INNER WEST

DEVELOPMENT ASSESSMENT REPORT

Application No.	DA/2020/1051
Address	15-27 McKell Street BIRCHGROVE NSW 2041
Proposal	Alterations and additions to existing townhouses at Nos. 15-27 Mckell Street
Date of Lodgement	22 December 2020
Applicant	Mrs Melissa R Hobbs
Owner	The Owners of Strata Plan No 62555
Number of Submissions	Nil
Value of works	\$505,750.00
Reason for determination at Planning Panel	Site Coverage variation greater than 10% within Strata Scheme
Main Issues	Site Coverage development standard variation Heritage / Streetscape impacts
Recommendation	Approved with Conditions
Attachment A	Recommended conditions of consent
Attachment B	Plans of proposed development
Attachment C	Clause 4.6 Exception to Development Standards
Attachment D	Statement of Heritage Significance

PROPOSED WEST ELEVATION

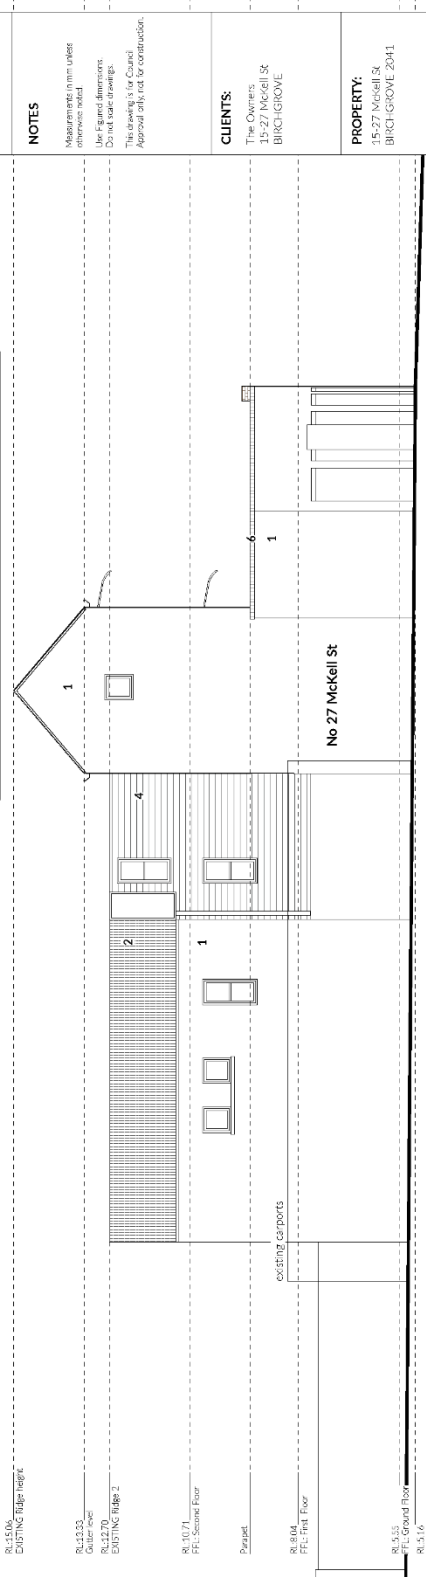
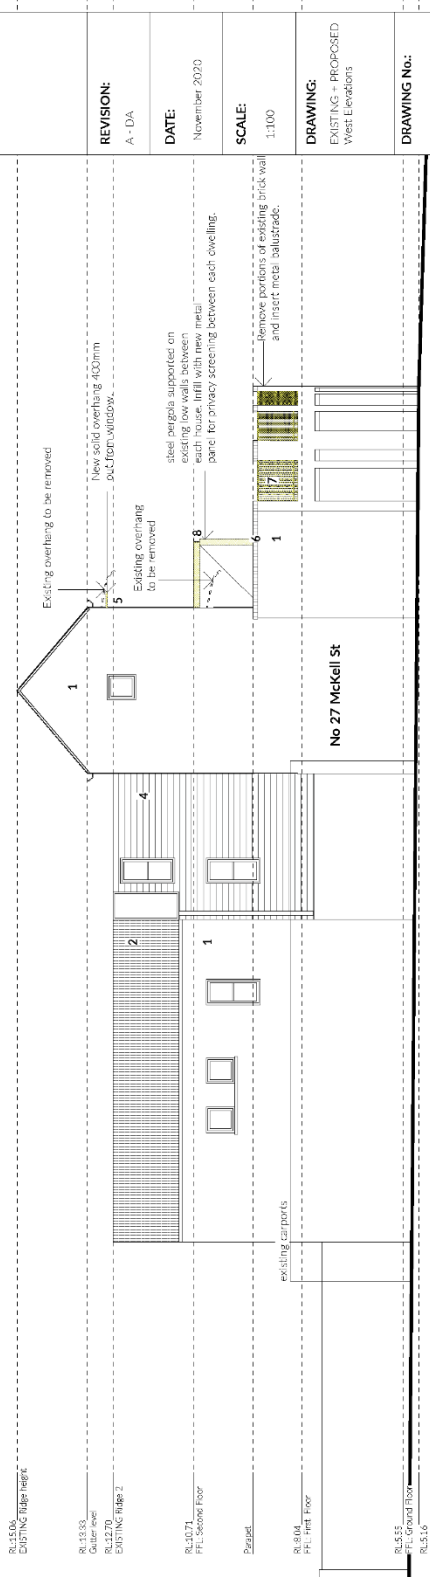
"I am generally in support of your proposals, however it would be my preference that the windows to the second floor be retained. Some alteration to these windows may be appropriate – for example adding a third window of similar proportion to make triple window compositions to replace the doubles. I do support replacement of the perspex awnings as you propose. I also suggest for the removal of the brick parapet to accommodate the metal balustrades the sill be raised by 150mm or so to increase the dimension above the head of the openings below. And maintain the reading of the brickwork mass."

The proposal includes the demolition of the first floor decks and metal balustrades to the McKell Street (south west) façade and construction of lightweight timber decks out to the curved parapet wall for the apartments 15 to 27. It is proposed to demolish the solid curved parapet above each ground floor opening and replace with a metal balustrade on the McKell Street façade to enable views to Mort Bay Park opposite and Mort Bay from Level 1 of the apartments and the new decks.

The construction of lightweight timber decks out to the curved parapet is generally acceptable, as this will not significantly alter the existing presentation of the development to the streetscape and its contribution to the Town of Waterview HCA. The decks will result in ancillary structures, including privacy screens, balustrades and planter boxes.

It is proposed to remove the existing Perspex and metal awnings over the windows and doors of the first and second level floors on the McKell Street facade. This is supported as per Ken Maher’s comments provided to the applicant. As such, the removal of the Perspex and metal awnings minimal impacts to the streetscape and the Town of Waterview HCA.

- a. A minimum of height of 800mm of the original curved brick parapet is to be retained above the head of the opening below
- b. The proposed partial demolition of the existing opening to the garage at No. 21 and the demolition of the perforated brick wall above is to be made good with matching brick repair rather than render so it continues to read as a brick element; and
- c. The new second floor level windows to the front façade shall comprise three separate vertically proportioned windows in accordance with Drawing DA06 Option D, prepared by Evans and Green and dated March 2021.
